North-South Road
Phase 1A
F.A.I. Proj. No. STP-8930(1)

STATE OF HAWAII DEPARTMENT OF TRANSPORTATION HIGHWAYS DIVISION	
PLAN AND PROFILE - 1	
North-South Road Phase 1A F.A.I. Proj. No. STP-8930(1)	
Scale: As Shown	Date: Dec 22, 2004
SHEET No. C2.2 OF	SHEETS

"AS-BUILT" CO 18

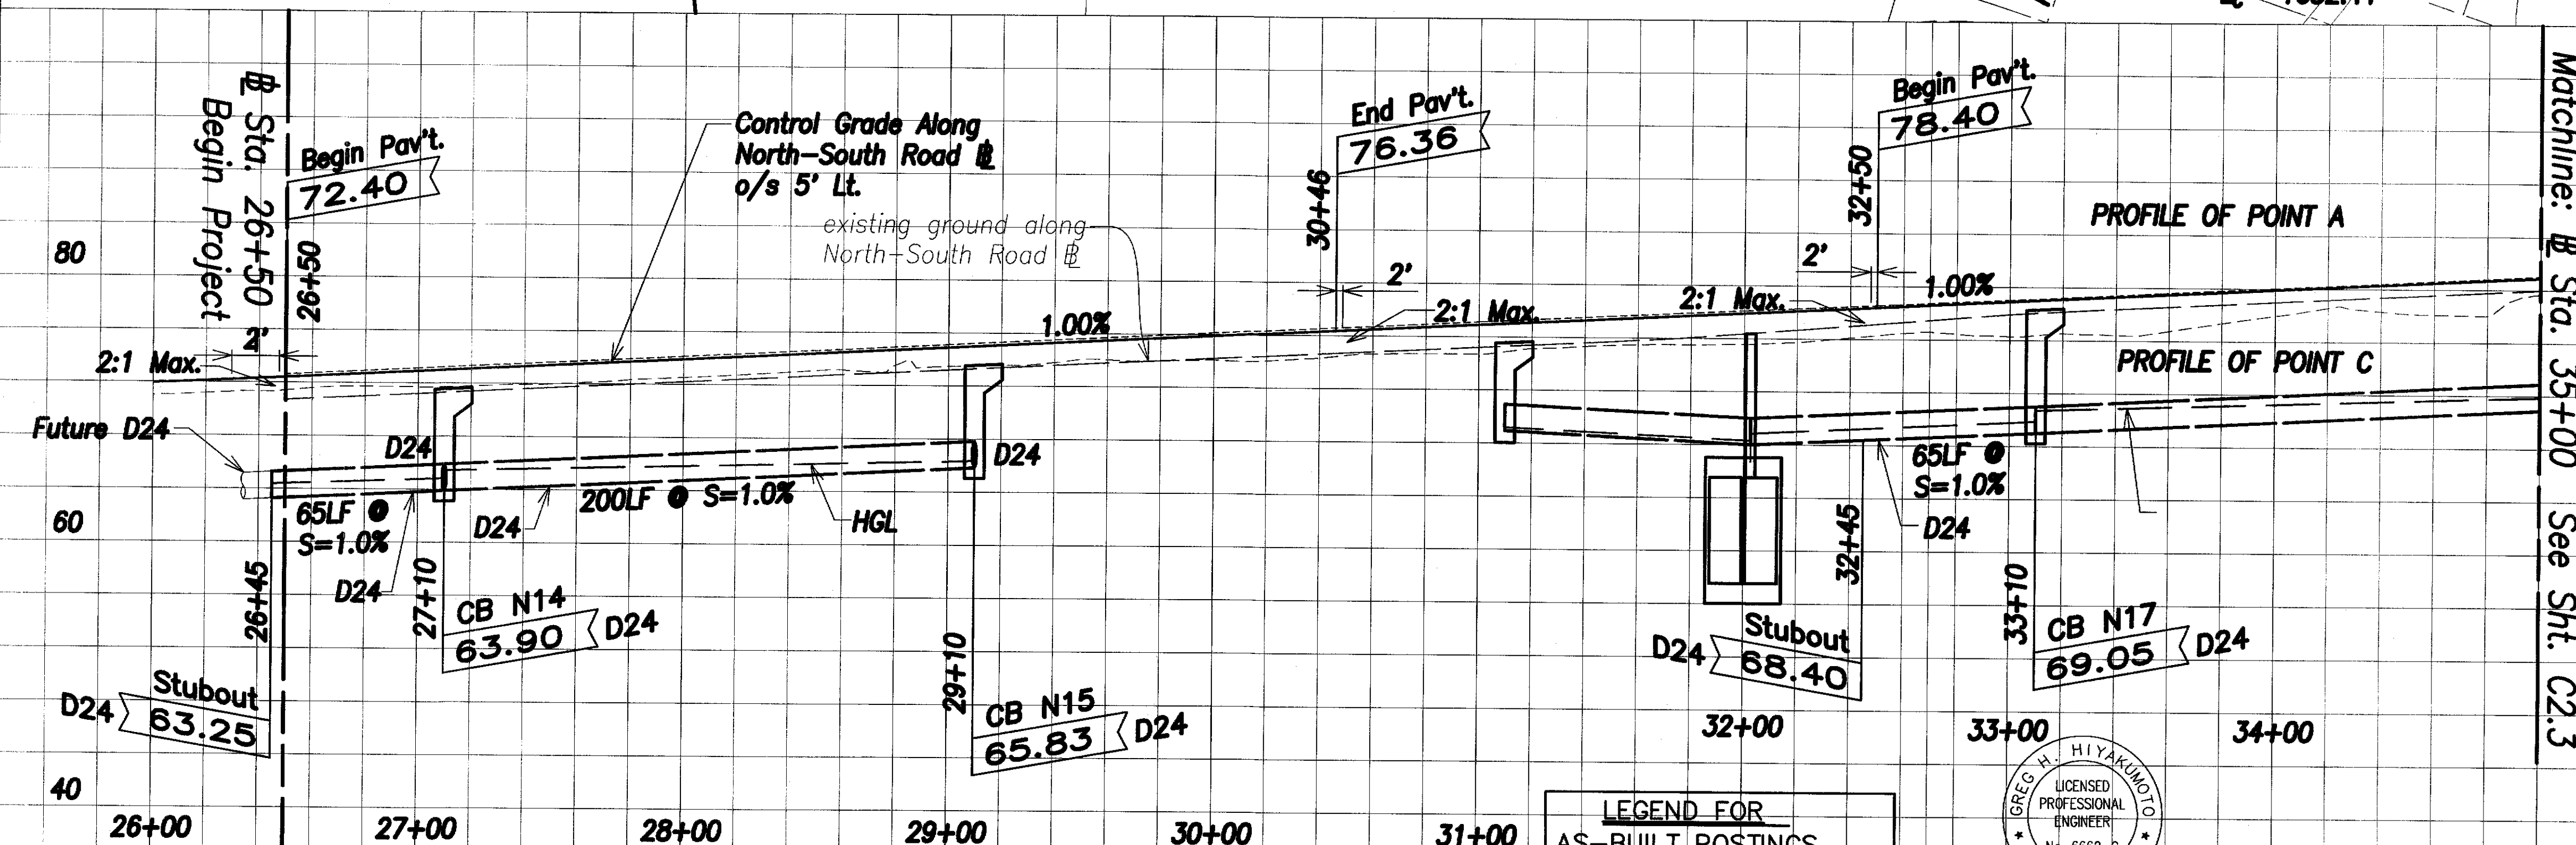
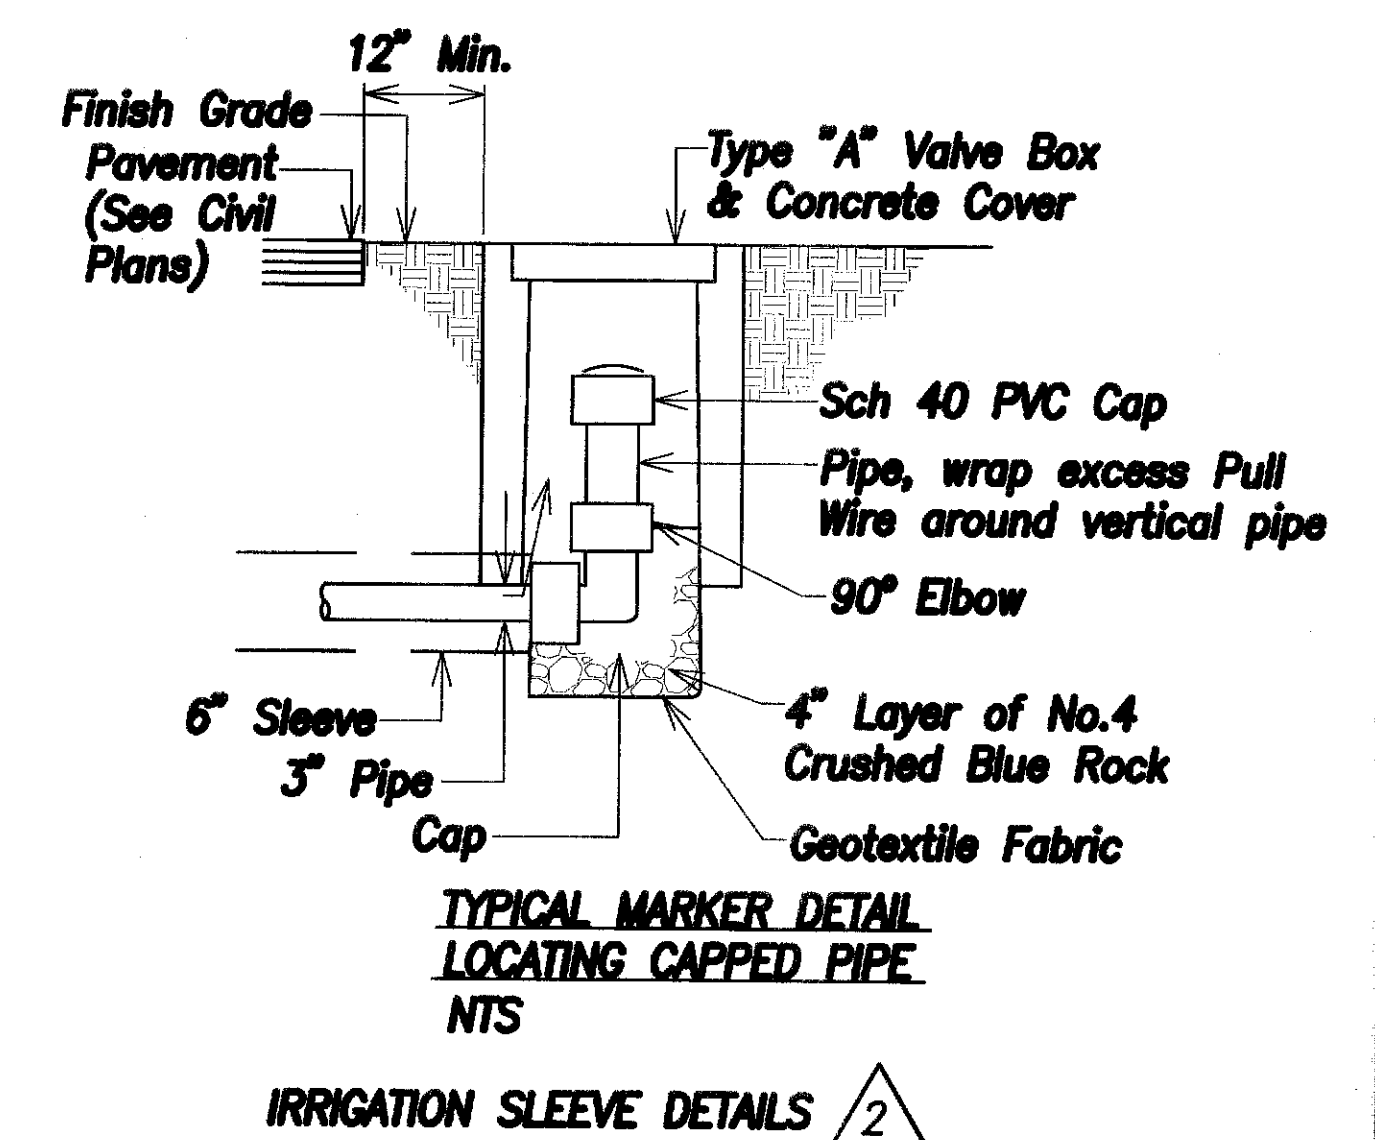
DATE	REVISION
3/30/06	As Built - RFI-16A
10/14/05	As Built - RFI 6
6/21/06	Deleted Culvert C, roadway from 30+46 to 32+50 (per SDOT), extended ditch

PLAN AND PROFILE - 2

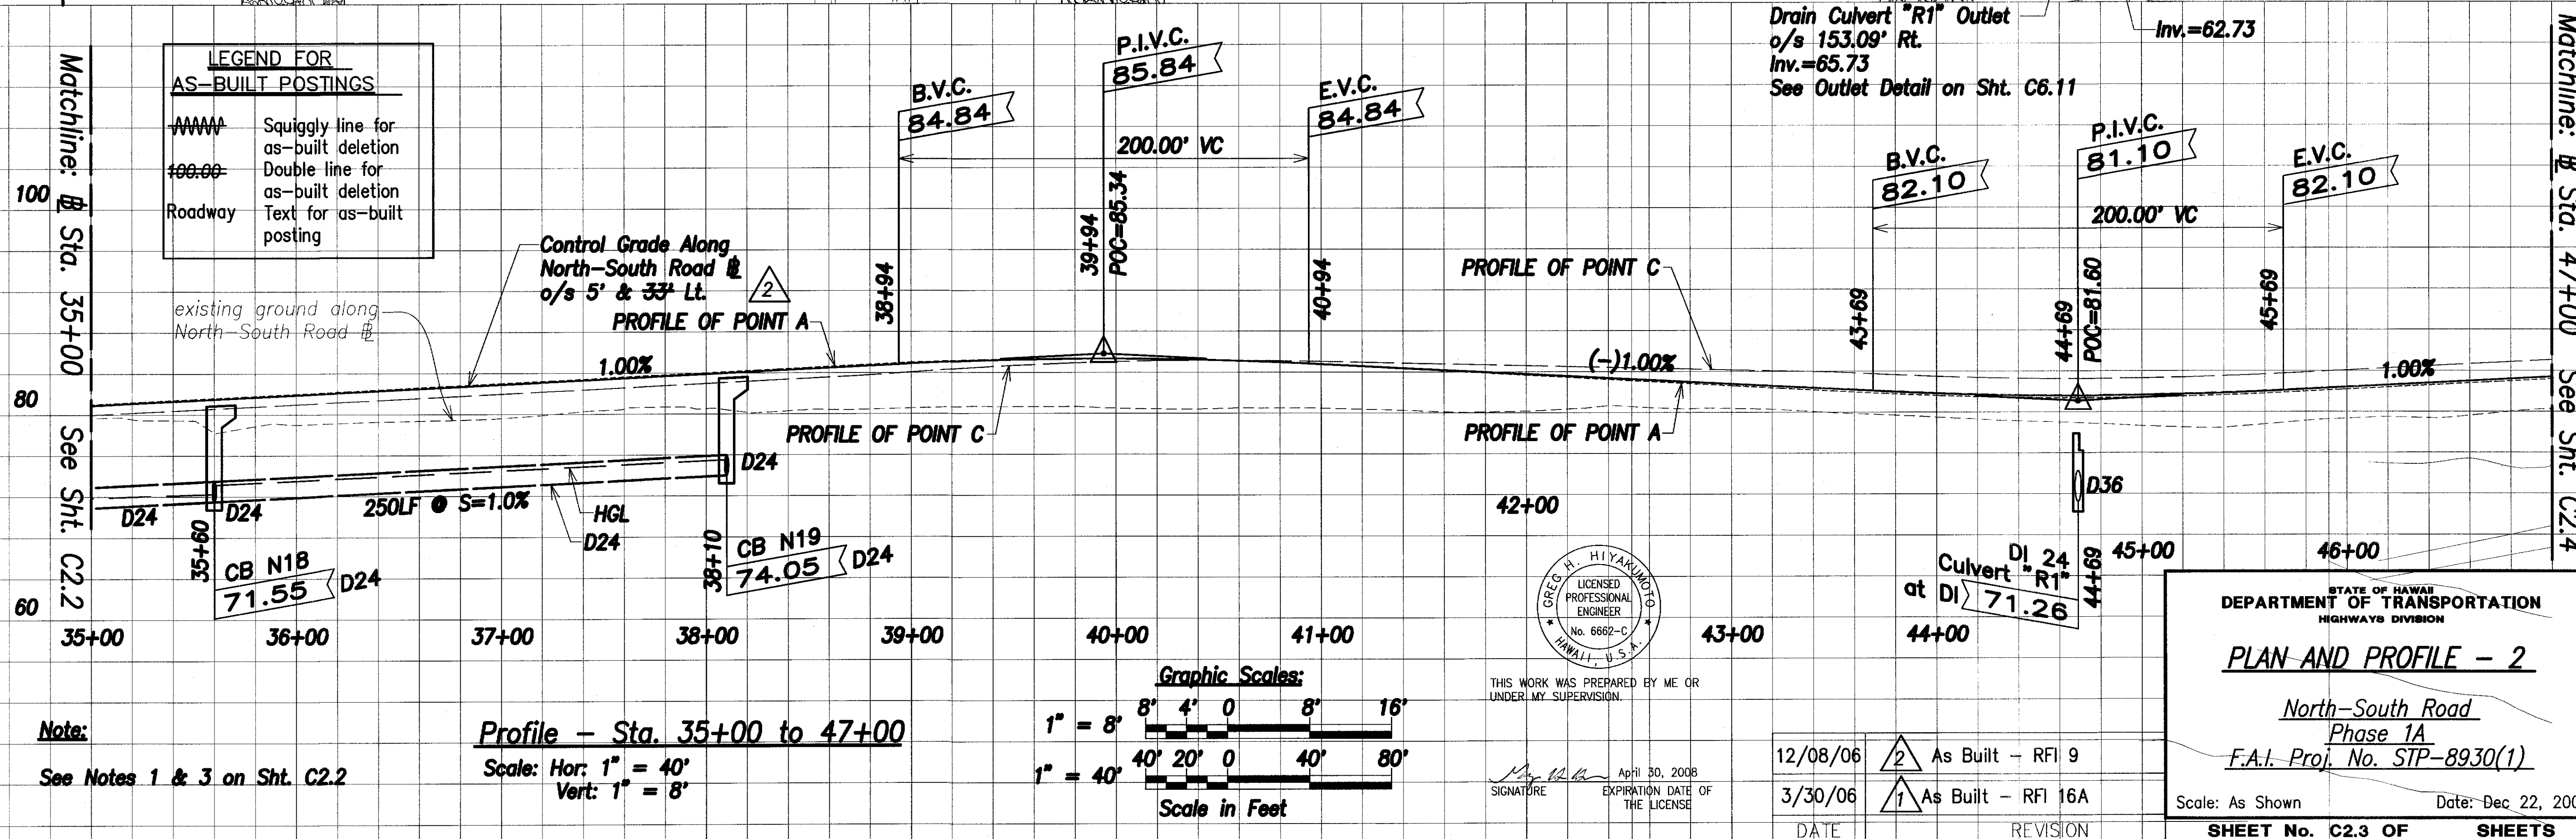
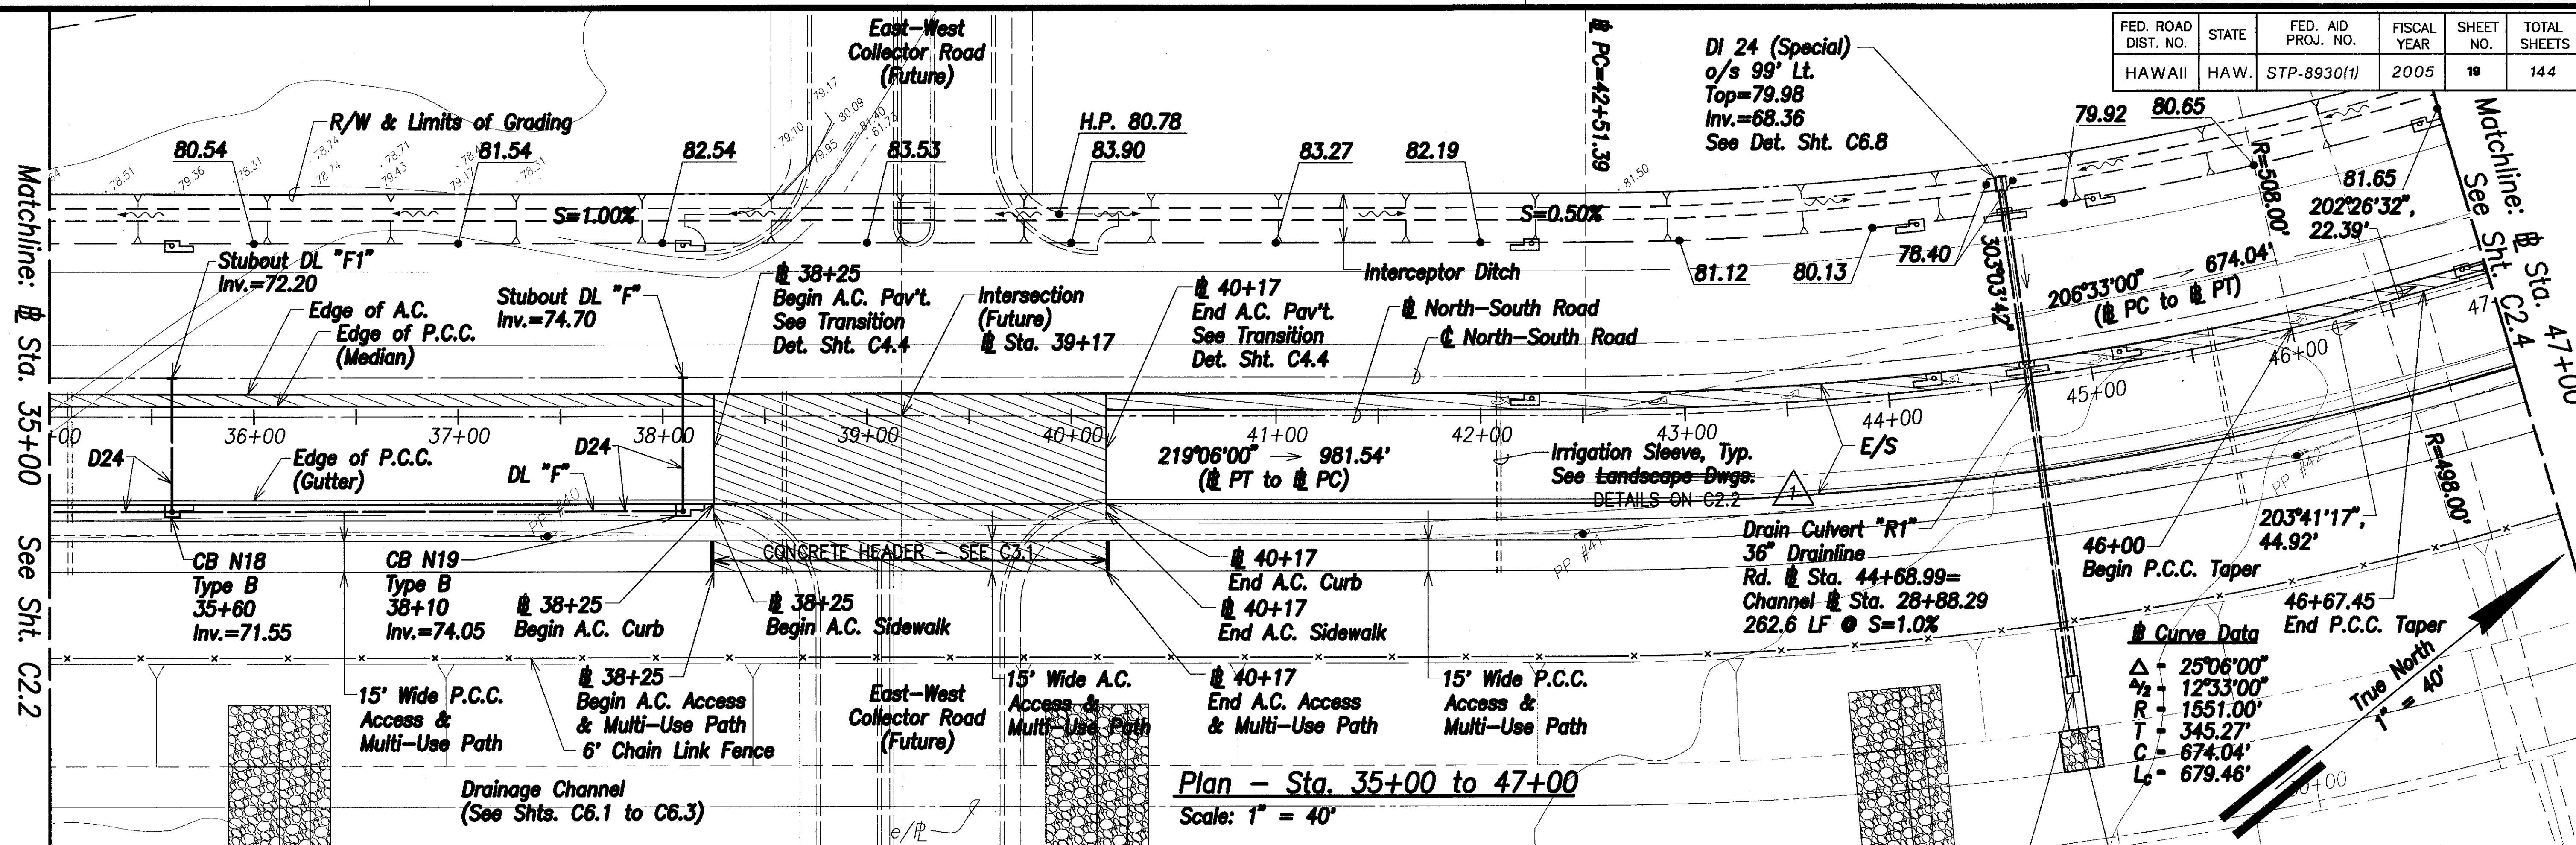
DATE	REVISION
12/08/06	As Built - RFI 9
3/30/06	As Built - RFI 16A
